To: Margaret Haynes, NMDOT Assistant District 3 Traffic Engineer

From: Chuck Huffine, PE, PTOE

Date: March 31, 2022

Re: 3/17/22 Comment Responses – Coffee Shop Development Traffic Impact
Study Northeast corner of NM 45 (Coors Blvd) and Brayton Rd
Albuquerque, New Mexico

SHEET TITLE
ARCHITECTURAL
SITE PLAN

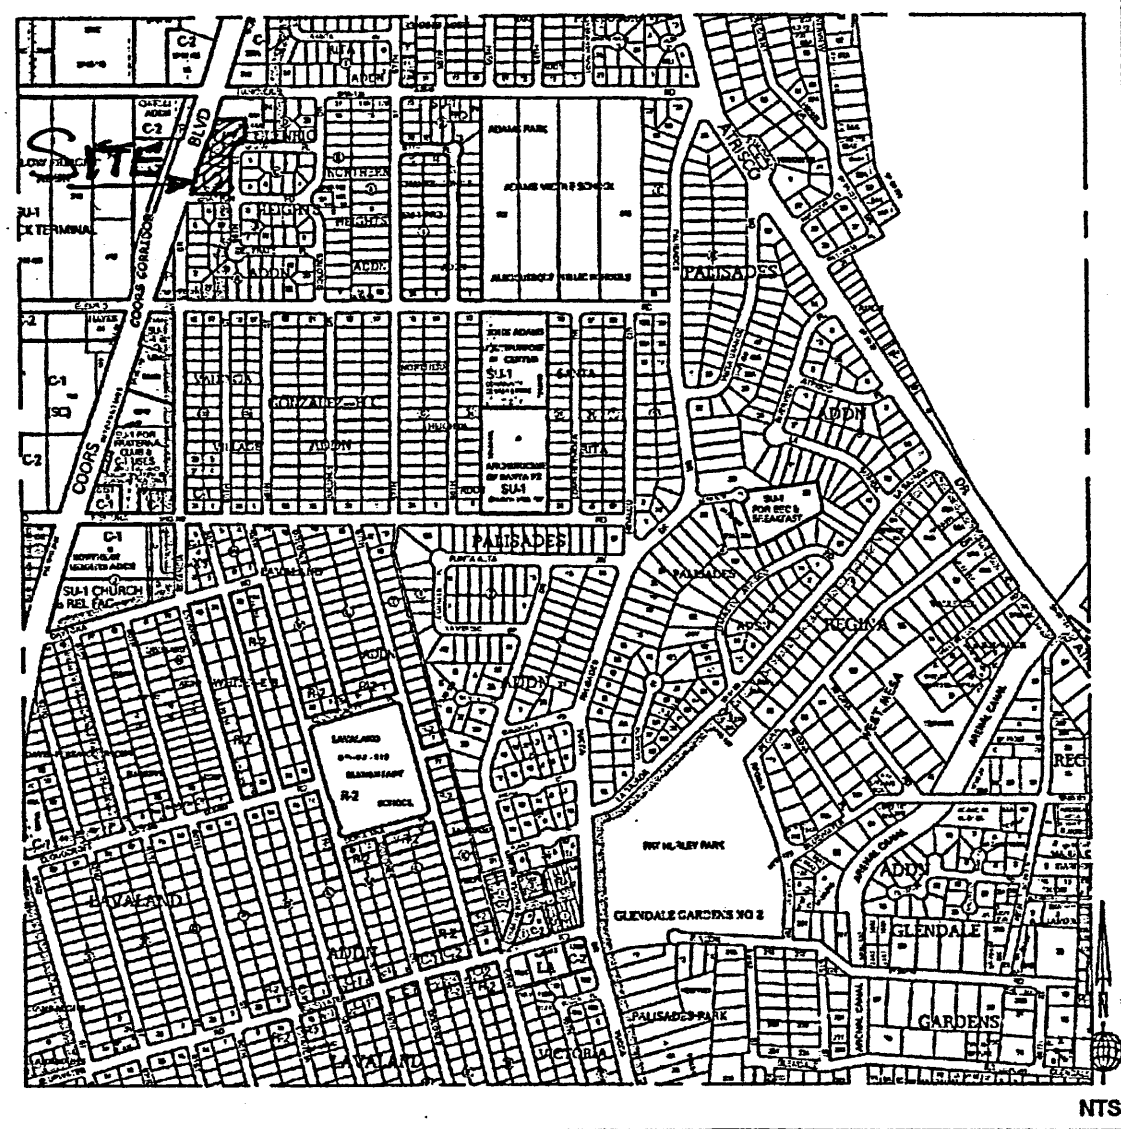
- 3) Include site plan within body of the report.

Response: Included as Figure 2.

PLAT OF
Lot A-3-A, Block D,
GLENRIO HEIGHTS
(formerly Lots A-2-A & A-3, Block D)
within the Town of Atrisco Grant
projected Section 14, T.10N., R.2E., N.M.P.M.
City of Albuquerque, Bernalillo County, New Mexico
December 2017

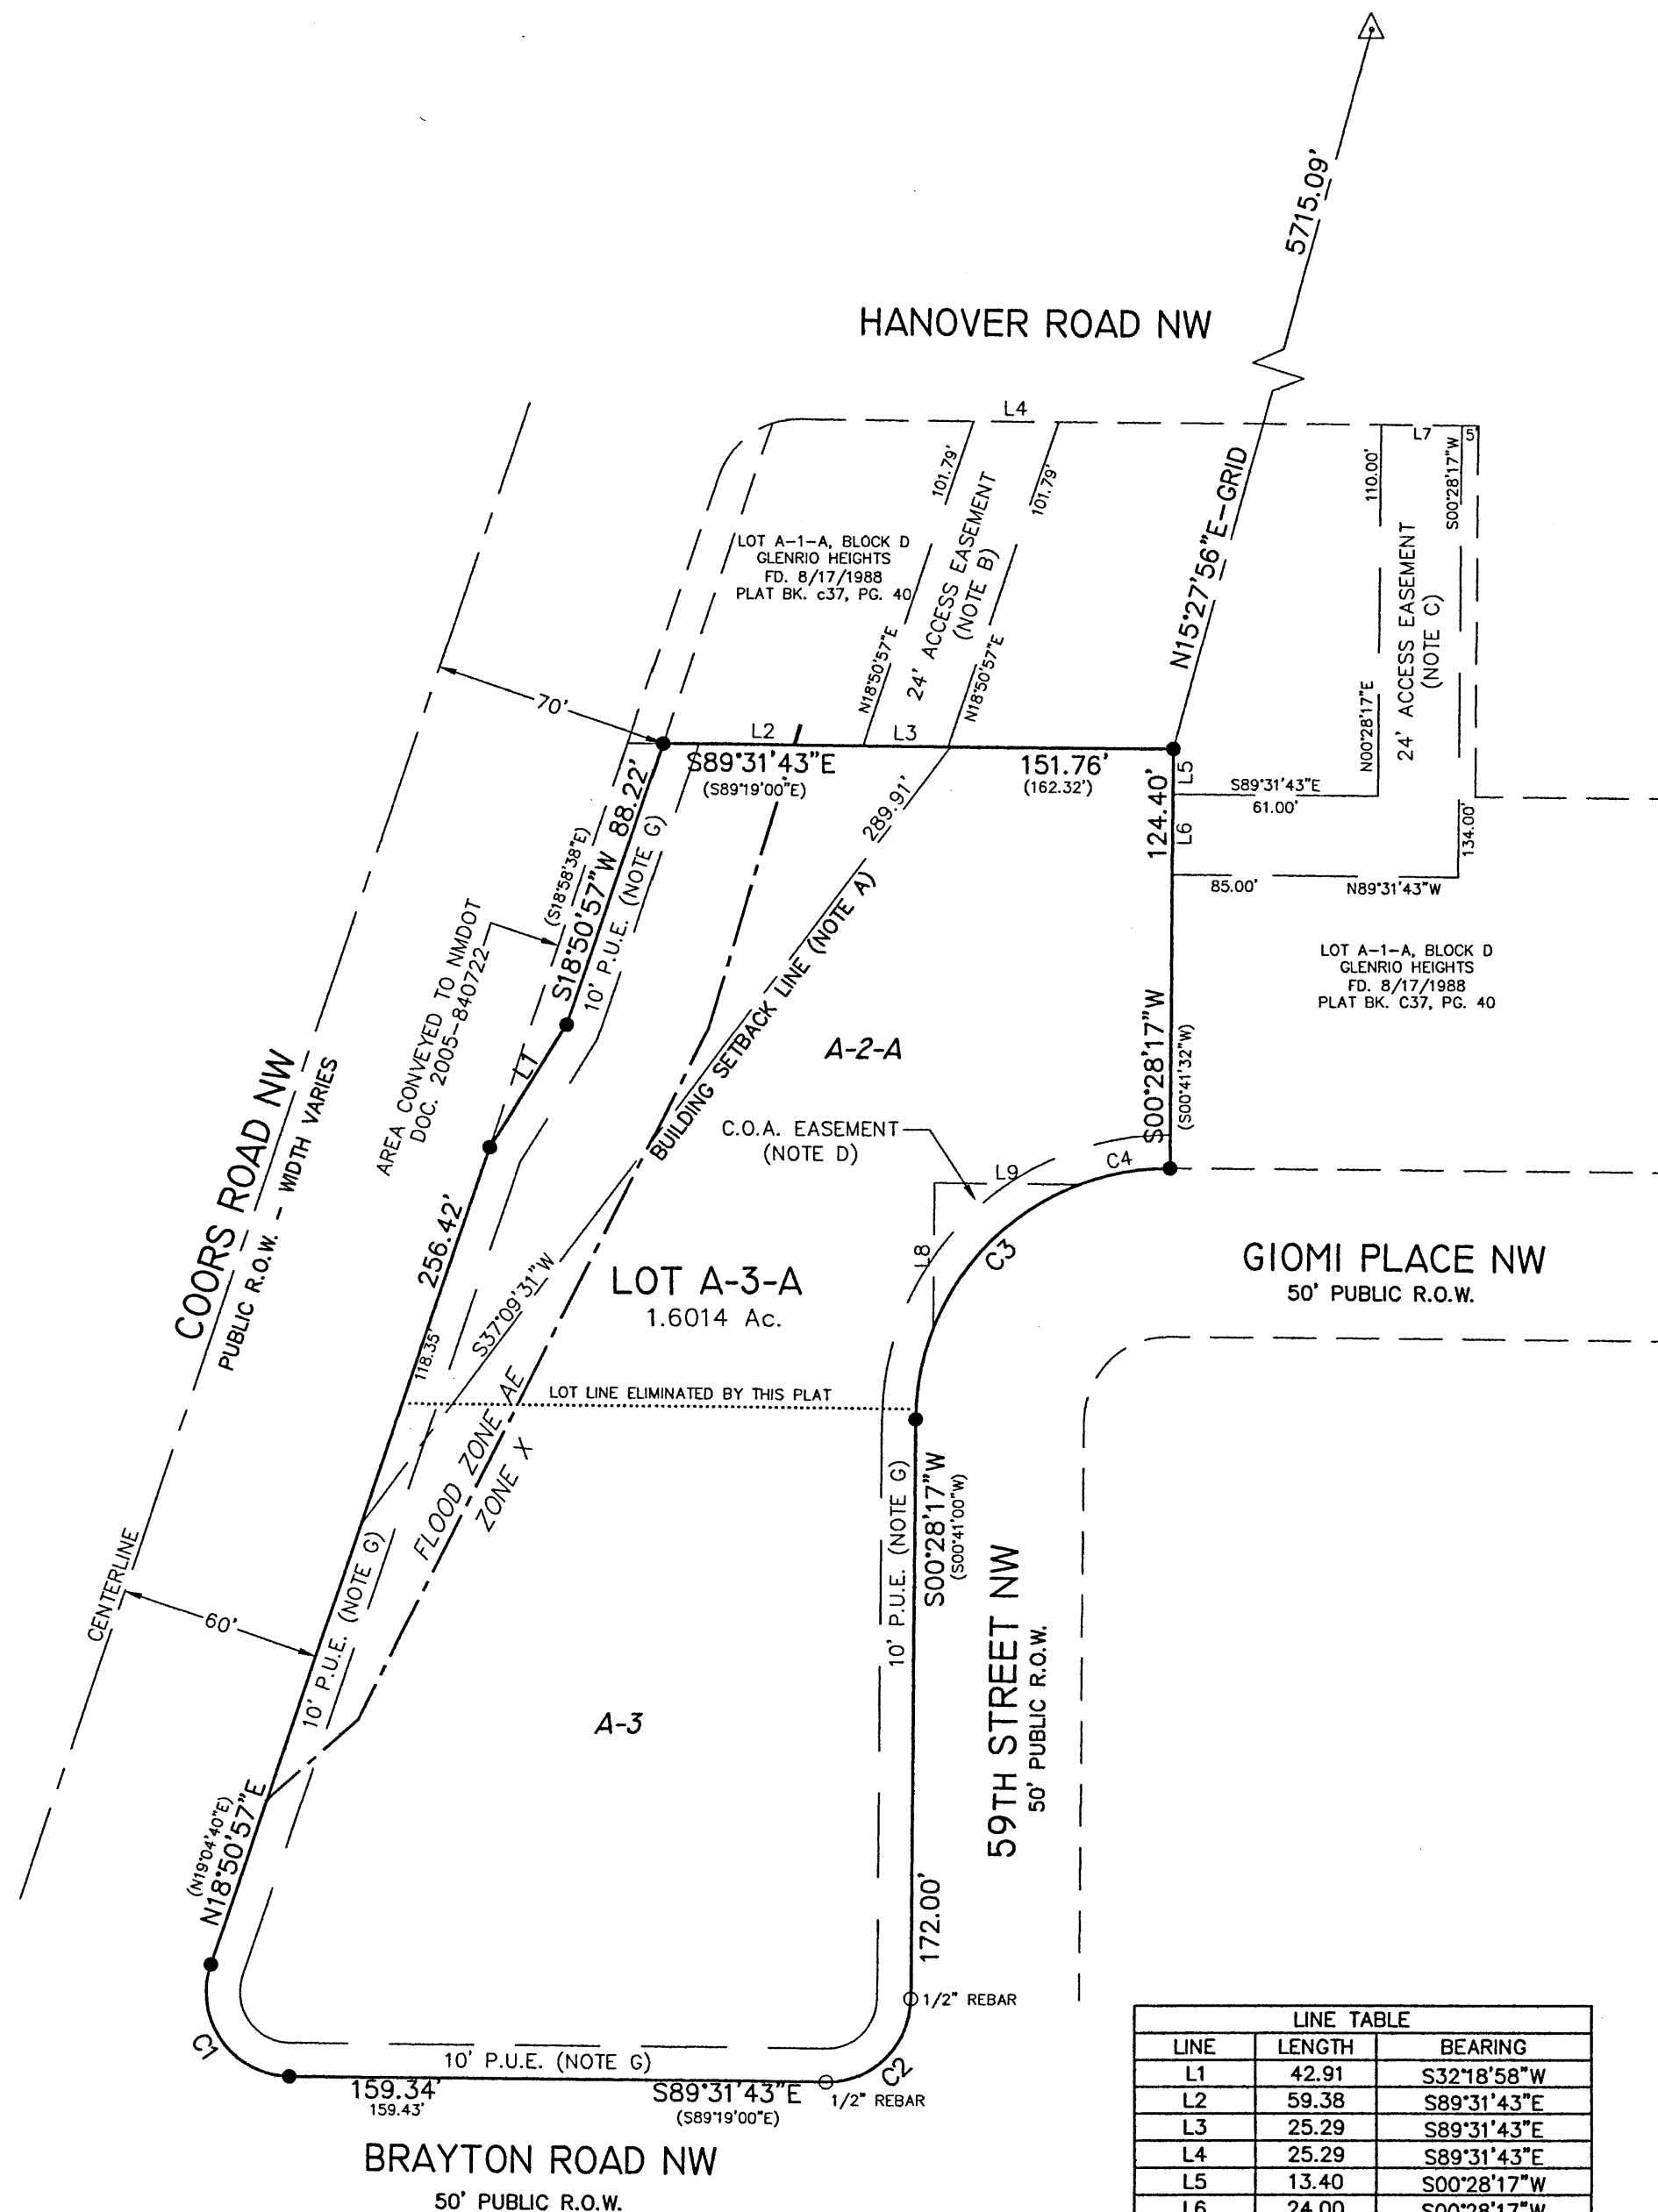
- 6) Please provide plat identifying the share access easement through the Taco Bell property. Summary tables with LOS for each lane approach should be inserted within the report document.

Response: Plat and easement info is attached to this memo.
